Reference: H09/0331/94

Description: Residential development, including means of access
and demolition of existing dwelling

Location : Battlefields Farm Battlefields Lane
Holbeach Spalding Lincs

RE: LAND AT BATTLEFIELDS LANE HOLBEACH - KINGSWOOD INVESTMENTS
(REF. PLANNING PERMISSION H09/0331/94)

RESIDENTIAL DEVELOPMENT, BATTLEFIELD FARM, BATTLEFIELD LANE,
HOLBEACH. (B.S. & R.B. COLE)

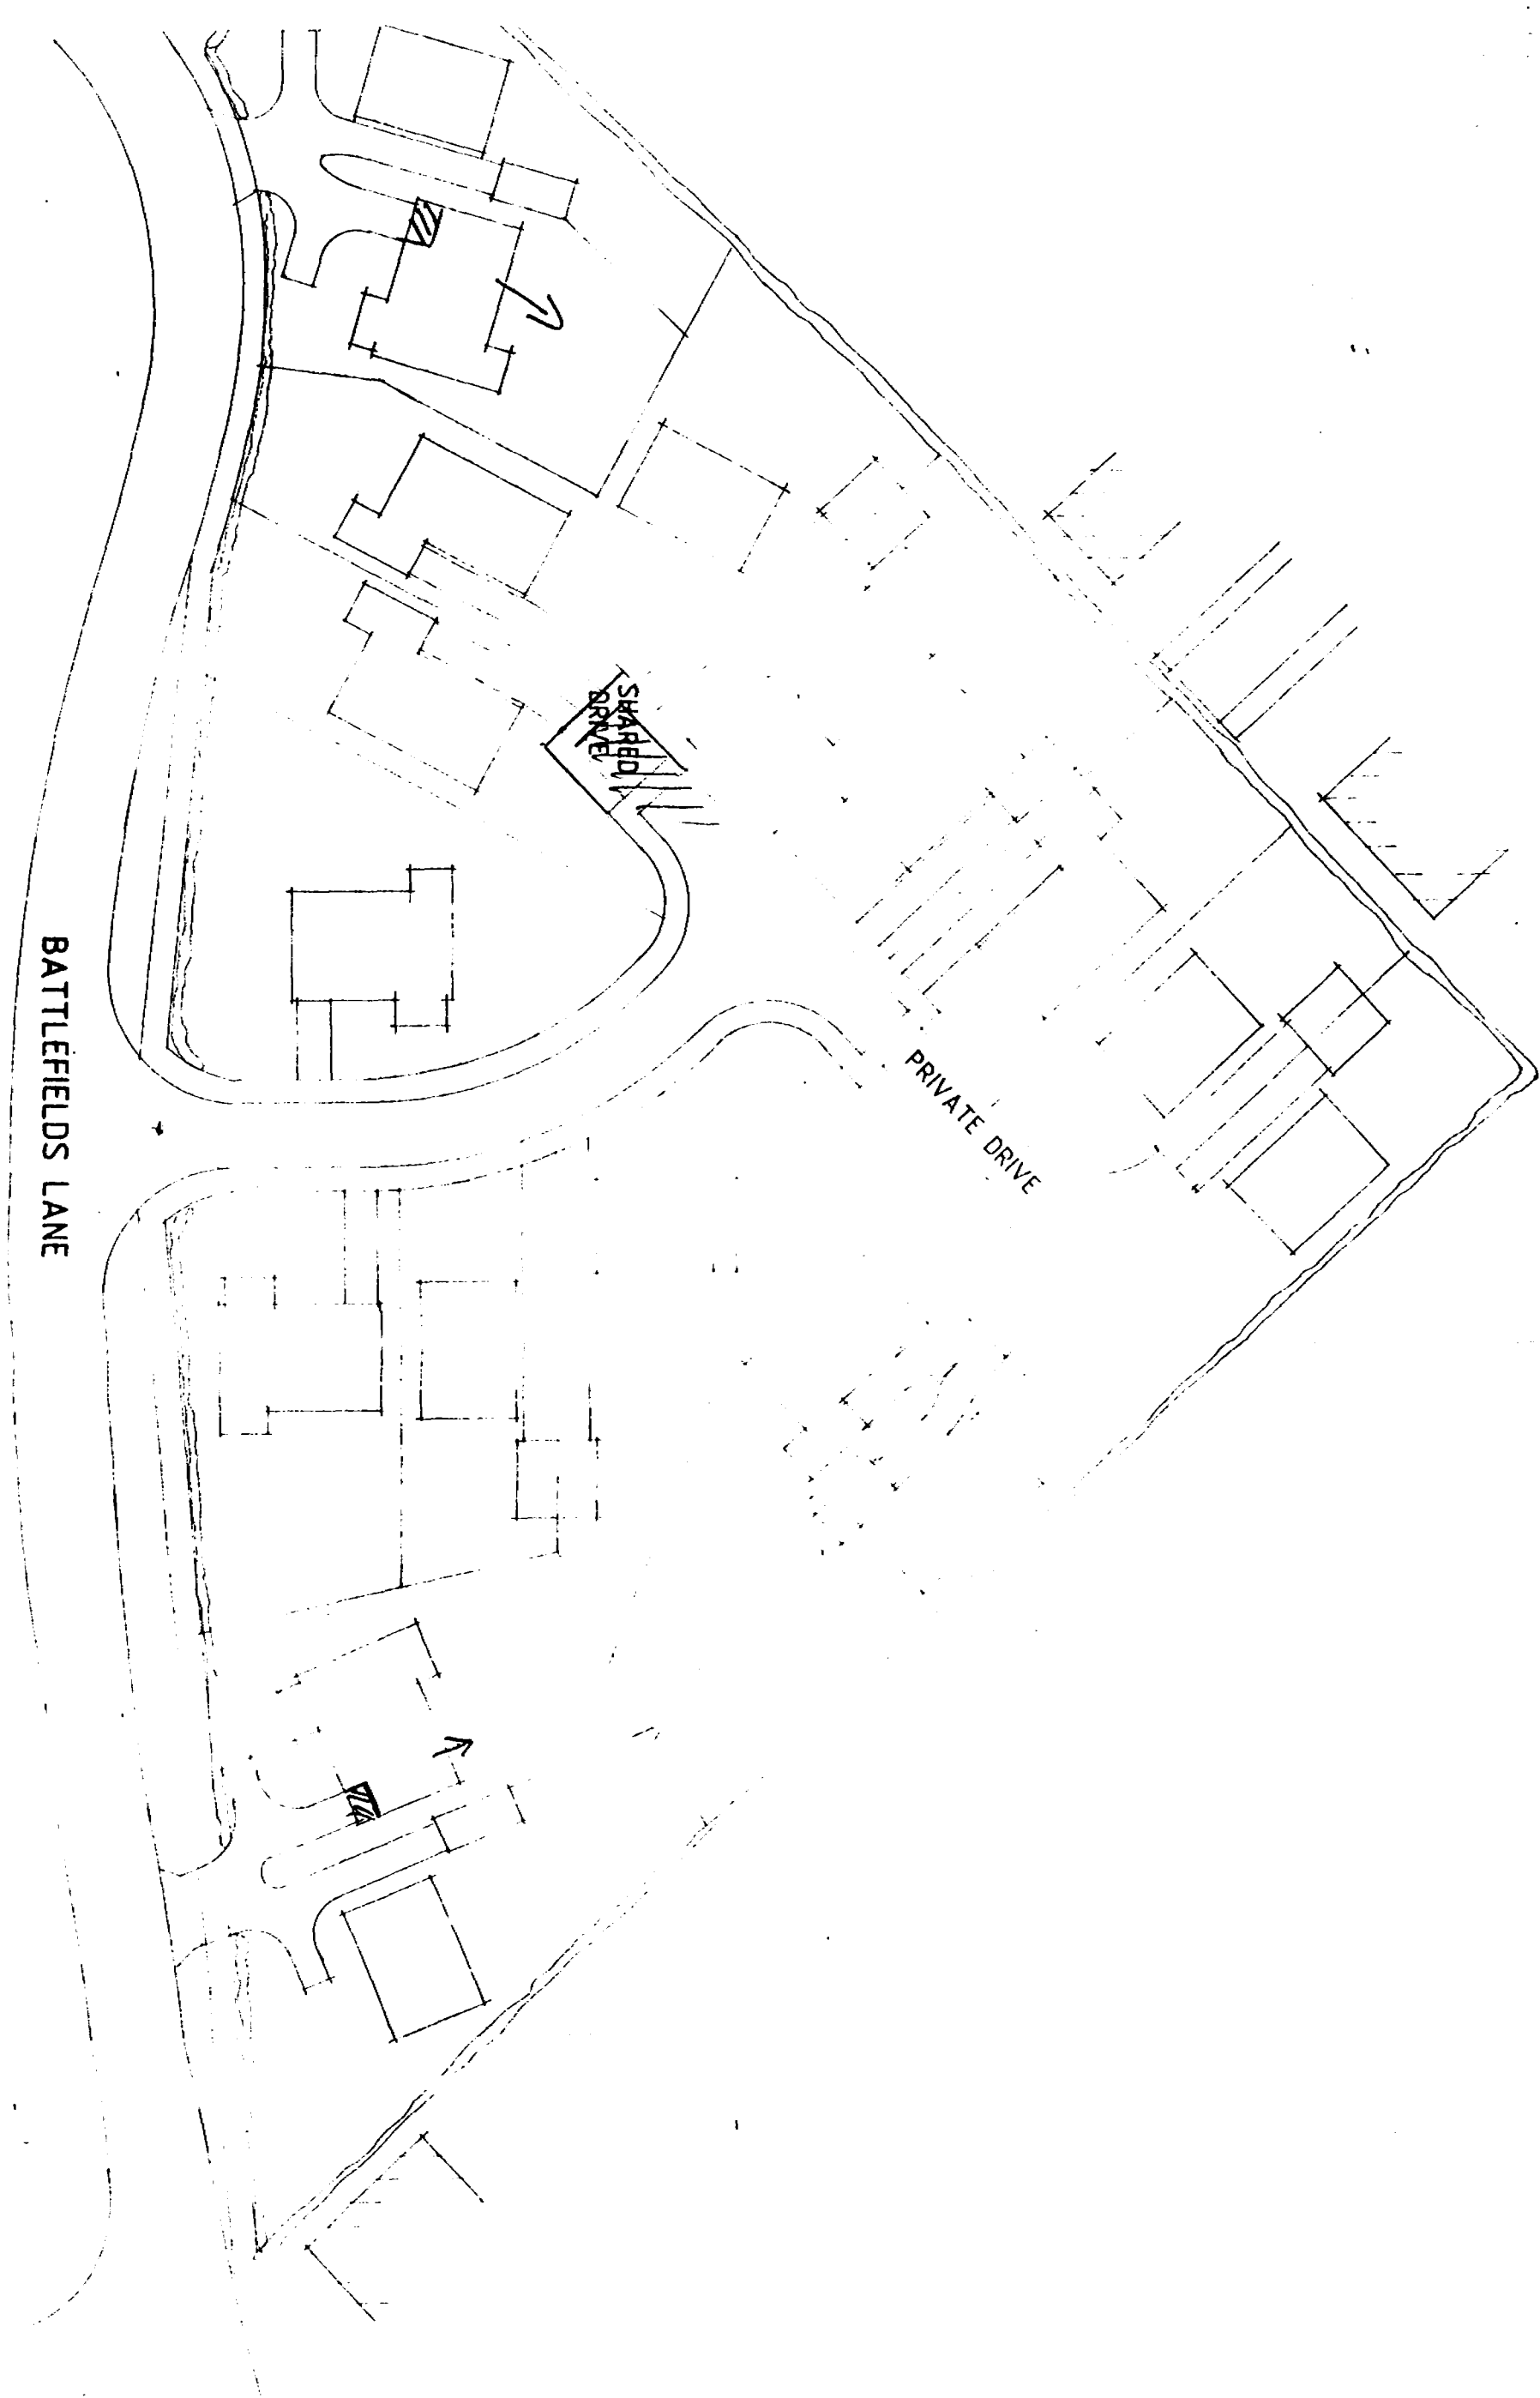
Firstly, it is considered that the alignment of the new road should be included within the application. I have sketched on an enclosed plan what I consider to be a reasonable alignment, which incorporates "traffic calming" measures.

Also, it is considered that sections of footway (as shown in pink on the enclosed plan) are not necessary and should be deleted in favour of grass verge.

Finally, indicative details are required showing the possible layout of the site and also landscaping, including details of which trees on the site are to be retained/felled. It is considered that the landscaping scheme should include new indigenous hedge planting along the site's frontage where the existing hedge is to be removed. This, of course, should be behind the visibility splay and also interspersed by trees.

1. Realignment of the road as suggested.
2. Alterations to the proposed footways and grass verges fronting Battlefields Lane.
3. Indicative tree and hedge planting to the front of the site and trees and hedges to be retained or removed.
4. Regarding your suggestion for an indicative site layout, my clients; and their advisors; feel that final layout of the site should be considered at the reserved matters stage, as they feel any indicative layout may prejudice the saleability of the site.

SOUTH HOLLAND D.C.
PLAN DEPT.
23 MAY 1994
REF: H99/0001/04

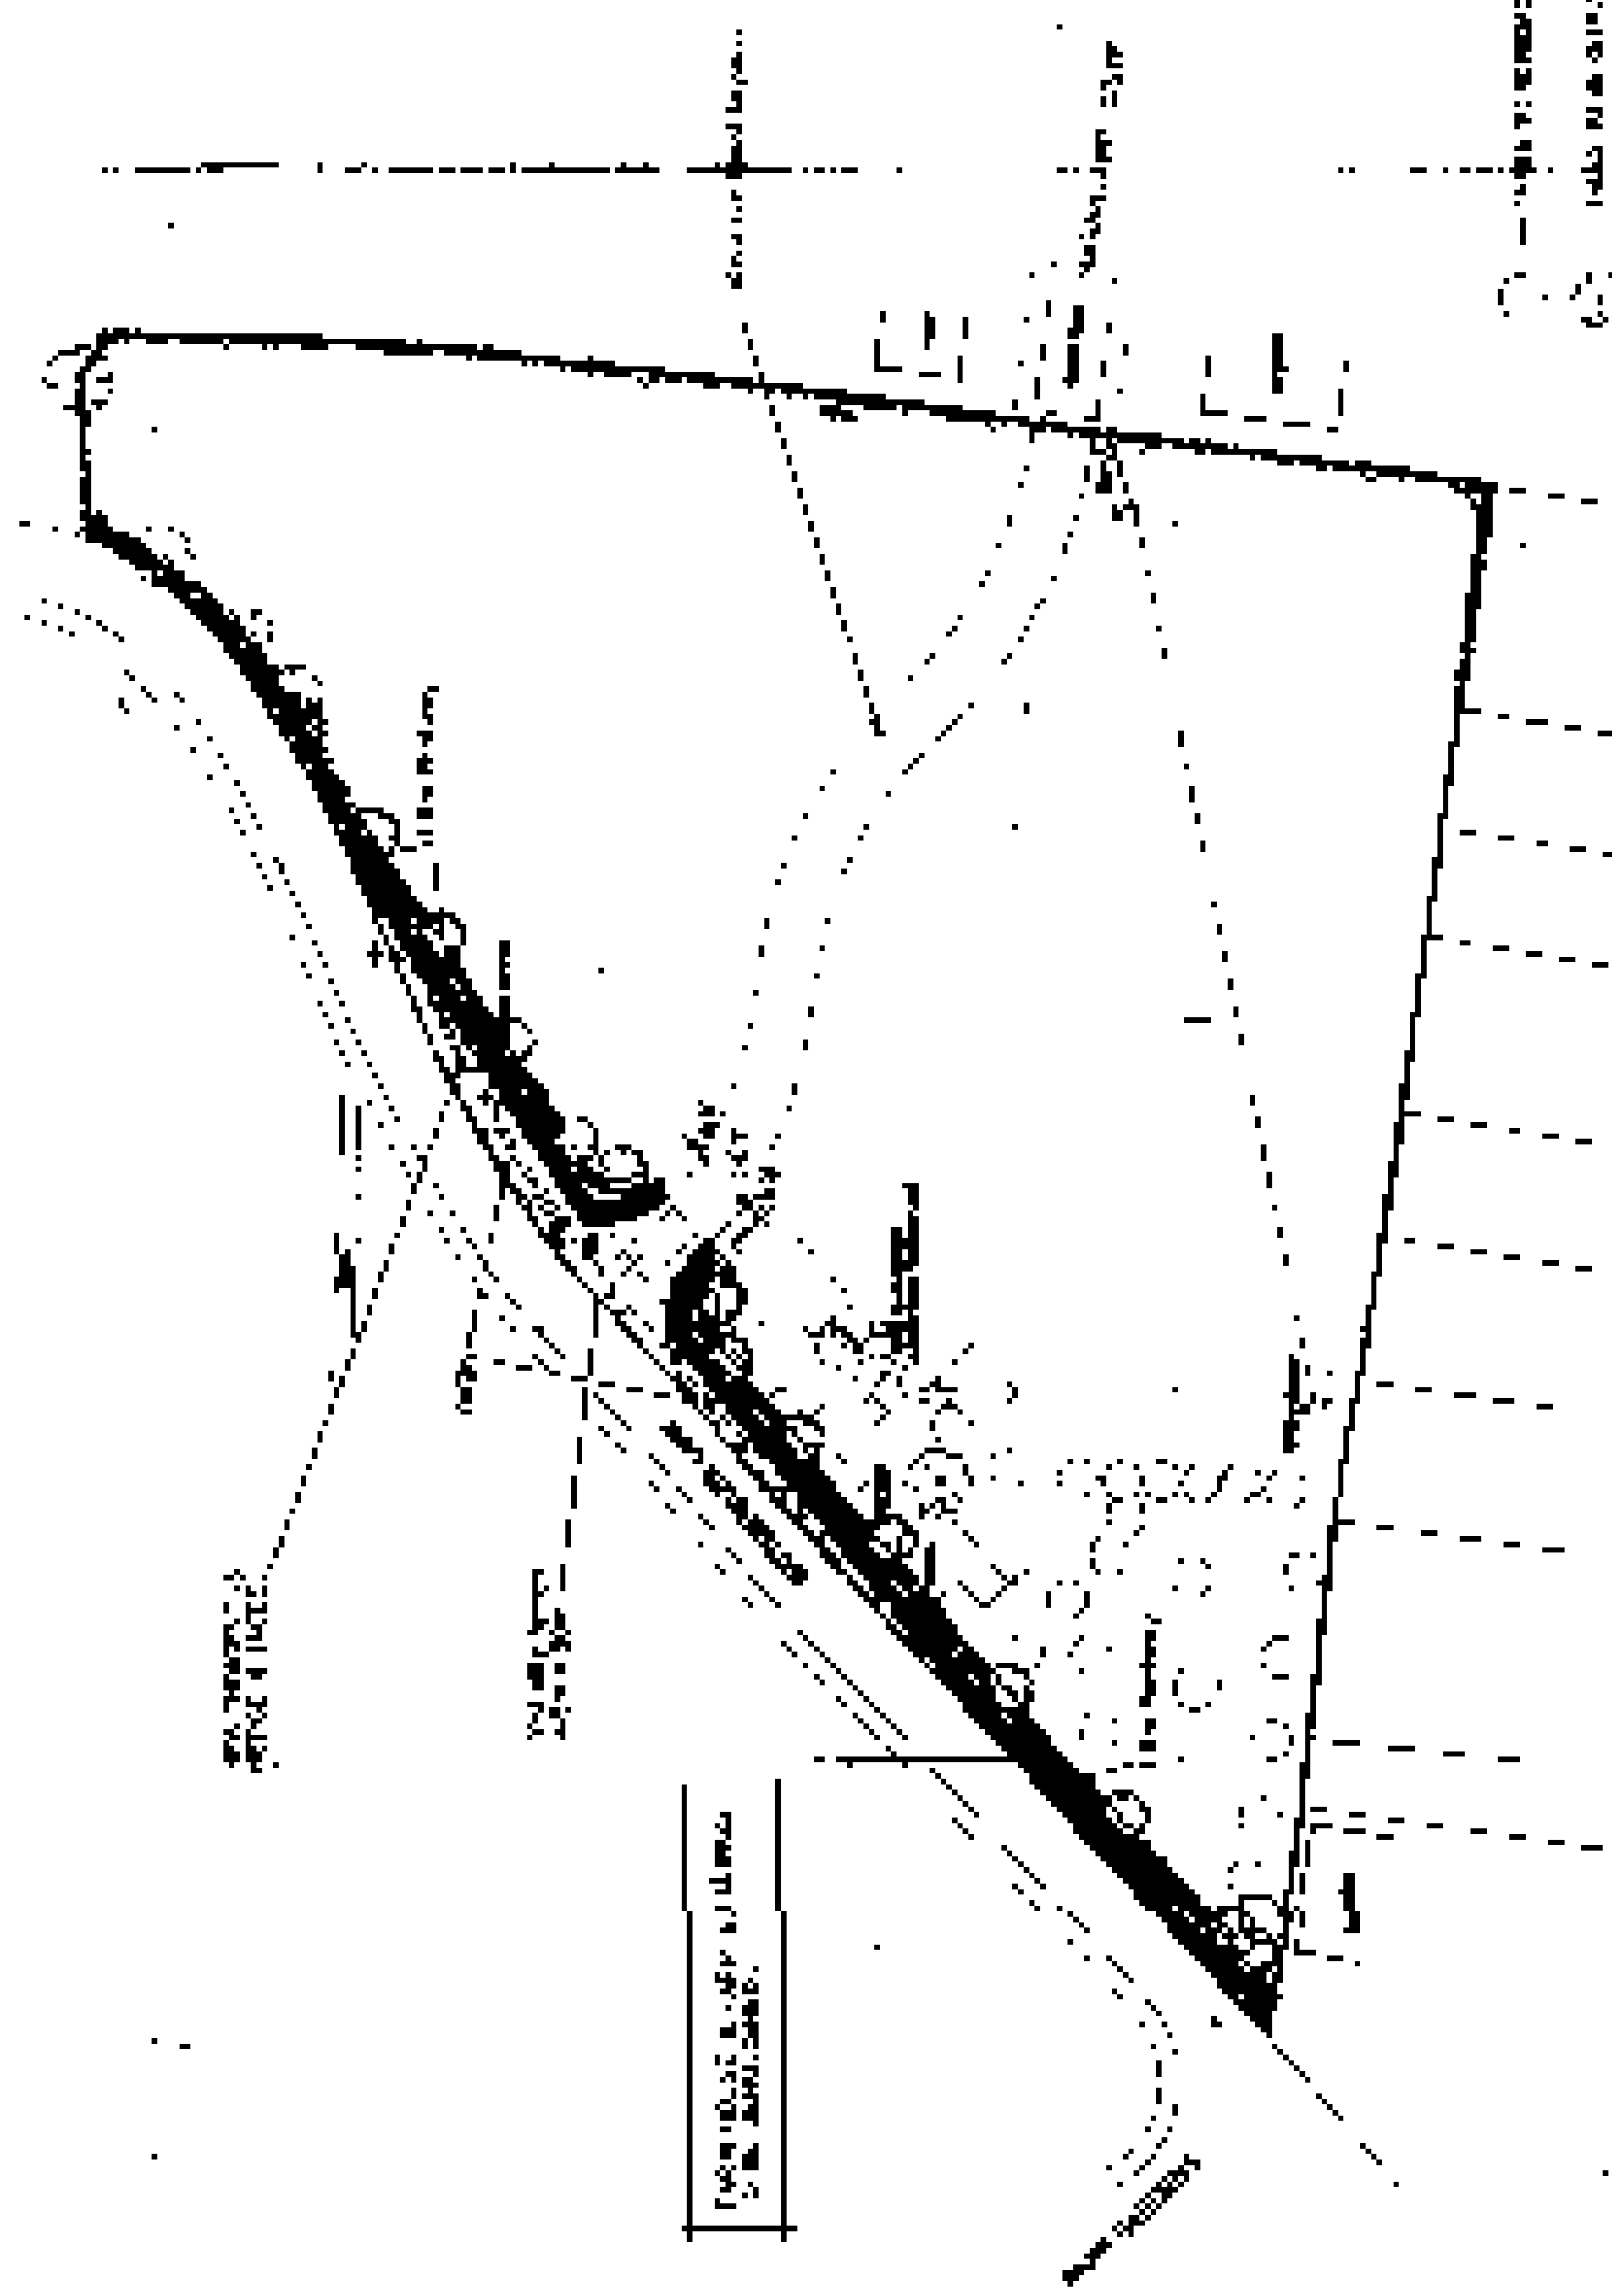
(5) Before any dwellings are occupied the ~~factory~~ shall be provided along Battlefields Lane as shown on the submitted drawing no BS & RBC 1/2 in accordance with details to be approved.

(6) The proposed estate road access shall incorporate 4.5m x 90m visibility splay as shown on submitted drawing no BS & RBC 1/2.

- 11 The proposed estate road access shall incorporate 4.5 metres by 90 metres visibility splays as shown on the plan accompanying the application (drawing no. BS and RBC1/2A received by the Local Planning Authority on 23 May 1994).
